Determination 2010/136

Refusal to issue a building consent for a house with straw bale walls at 13 Hays Rise, Governor's Bay, Lyttelton

2.4.2 The construction of the two-storey-high walls appears to be as shown in Figure 1:

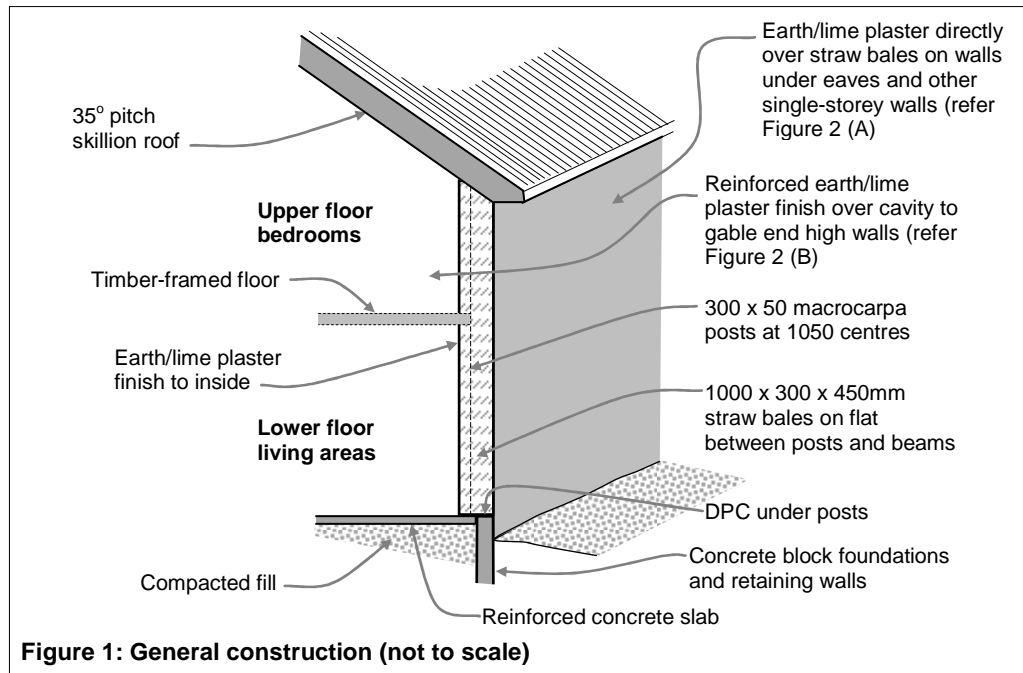
I note that the two-storey walls extend to about 4m height under the north eaves and more than 7m at the apex of the gable end east walls. For this house, use of the earth standards recommendations would imply roof overhangs far beyond that provided by the proposed 600 mm roof overhangs and points strongly to the need to employ additional rain-screening techniques such as cavities on all walls.

2.5.2 The general construction of the directly plastered straw bale walls and the straw bale cavity walls is shown in the sketches in Figure 2:

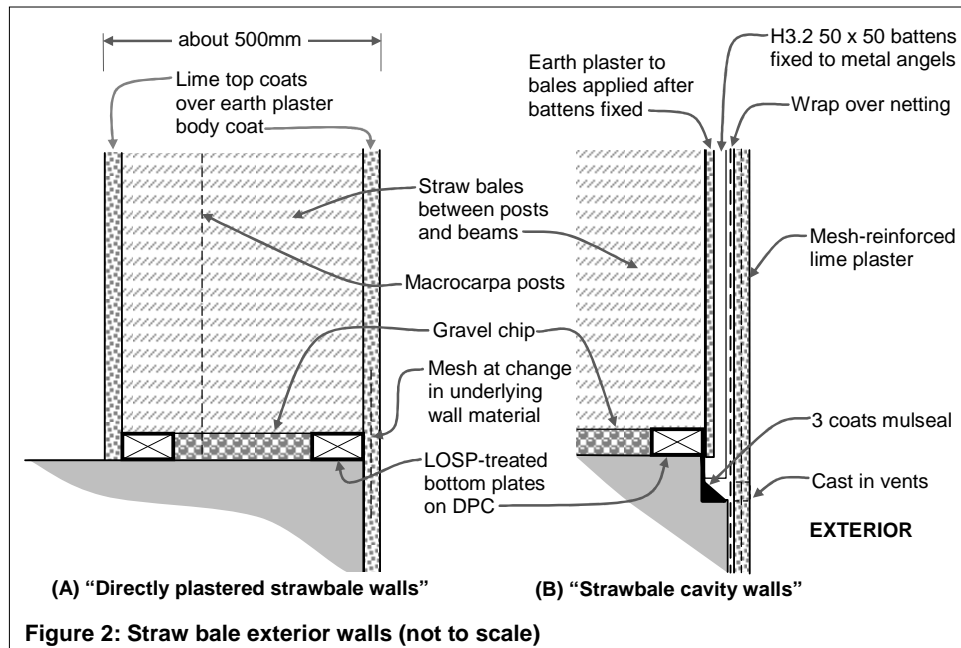
- there is no mention of how the straw bales are to be attached to post, beams and other structural elements
- netting is not required providing bales are very tightly compressed and it is not clear how straw bales will be compressed
- at the bottom of the straw bale walls, the extension of the DPC under the full width of the wall is recommended.

- building paper should be installed over netting and pulled tight, and the cavity battens should be spaced at 300mm centres maximum
- batten fixings appear to remain unresolved, and these should be confirmed by a structural engineer as adequate for the weight of the solid plaster
- there is no mention of the proposed paint or coating system, which needs to remain 'highly breathable' over the lime-based plaster, even for a cavity situation, to help keep the cavity and wall behind dry.

- the front of the concrete jamb extends past the cavity, resulting in thin plaster at the rounded corner, which will be prone to cracking
- the jamb flashing is well back behind the head flashing, and it is not clear what happens at the junction
- with jamb flashings extending into rebates in the timber jambs, it is not clear how the windows can be installed
- the jamb flashings cannot overlap the sill flashing above the concrete sill, so it is not clear how water reaching jamb flashings can be directed to the outside.

6.3.1 Taking into account the expert's report, there are other areas where I consider that some details in the original consent documentation are missing, unclear or are not sufficient to ensure the resistance to external moisture, including:

- in regard to the straw bale wall construction:
 - clarification of junctions of straw bales with the structural elements
 - clarification of the installation and compression of straw bales

- the lack of a damp proof membrane under the full width of the walls
- in regard to the straw bale cavity walls:
 - the inadequate spacing of the cavity battens

- engineer's confirmation of the adequacy of batten fixings
 - the specification of paint and coating finishes to the solid plaster
- in regard to the plaster systems, the lack of clarity regarding:
